SUNDRY NOTICES AND REPORTS ON WELLS
(DO NOT USE THIS FORM FOR PROPOSALS TO DRILL OR TO DEEPEN OR PLUG BACK TO A DIFFERENT RESERVOIR. USE "APPLICATION FOR PERMIT" (FORM C-101) FOR SUCH PROPOSALS.)

Maverick Permian is requesting approval of the attached P&A plan.

East Vacuum GB-SA Unit 2175-002 P&A Procedure

Maverick Permian LLC
East Vacuum GB-SA Unit 2175-002
API# 30-025-02849

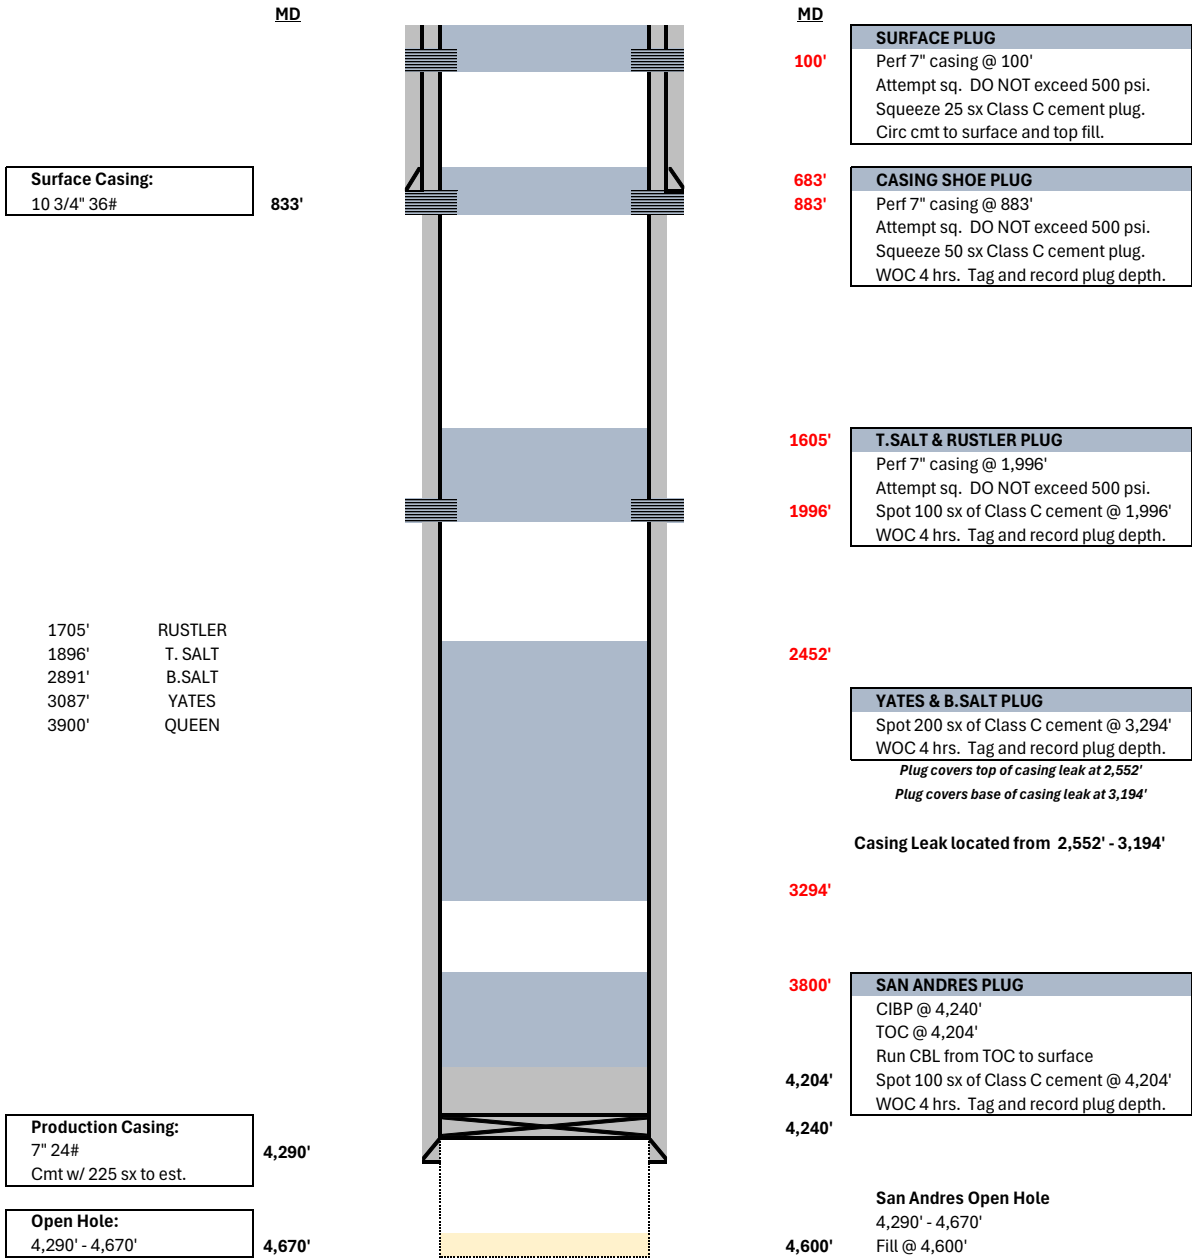
Must use corrosion resistant cement and CR CIBP

6. Run CBL from 4,204' to surface. Any cement plug above TOC will require perf and squeeze. Reference CBL run.
7. **Run Pipe Inspection Pipe Evaluation log 4200' - Surface**

13. **Yates & B. Salt Plug:**
Plug covers top of casing leak at 2,552' and base of casing leak at 3,194'. Spot 200 sx **Corrosion Resistant** cement plug at 3,294'. WOC 4 hrs. Tag at 2,452' or higher. Record cement plug top. **Test Casing 500psi/30min - Bubble test**

Created By	Condition	Condition Date
gcordero	Must run pipe inspection pipe evaluation log to surface - Submit to OCD permitting	3/14/2025
gcordero	A Cement Bond Log (CBL) is required to be submitted to electronic permitting.	3/14/2025
gcordero	Submit Cement Bond Logs (CBL) prior to submittal of C-103P.	3/14/2025
gcordero	Adhere to current Plug & Abandon (P&A) Conditions Of Approvals (COA).	3/14/2025
